MAYOR & COUNCIL COMMUNICATION

AGENDA ITEM: Hammes Estates Residential Subdivision - Final Plat (Phase 1)

SUBMITTED BY: Nick M. Johnson, City Planner

PLANNING COMMISSION
DATE: 9/22/13
AGENDA ITEM: 4A – BUSINESS ITEM
CASE # 2014-44

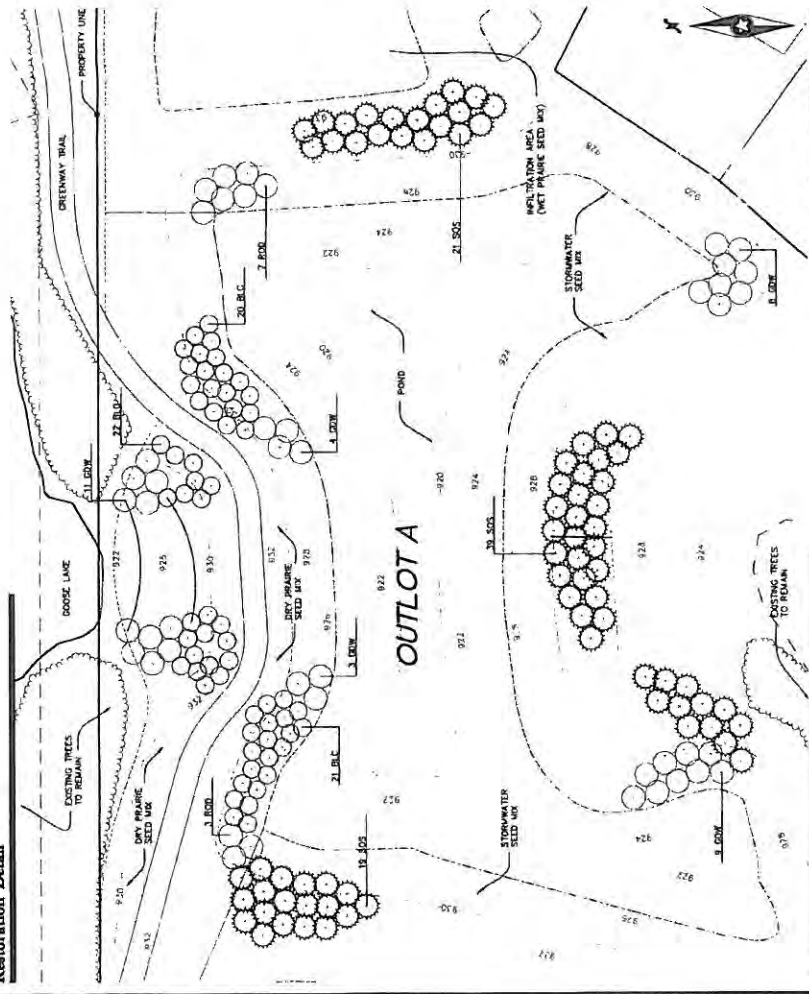
Ames thought he remembered a small park internally in the neighborhood that would have a play structure. He is not sure that a play structure near a 55 mph roadway is a good place for a play structure. Ames also questioned where neighborhood children would play, as lot sizes looked small to consider private play sets.

Zuleger pointed out that the Lake Elmo Park Reserve was located a mile north of the development, with a phenomenal play set. Ames stated that he didn't feel current playgrounds were within reasonable walking distance for residents. Hietpas shared that she didn't feel that the green spaces included throughout the development were large enough for community meeting spaces.

Zuleger pointed out the location of neighboring parks in Stonegate and Lennar neighborhoods.

The commission requested that a location central in the neighborhood be considered for play structure placement. Zuleger said that he would forward their comments to the developers.
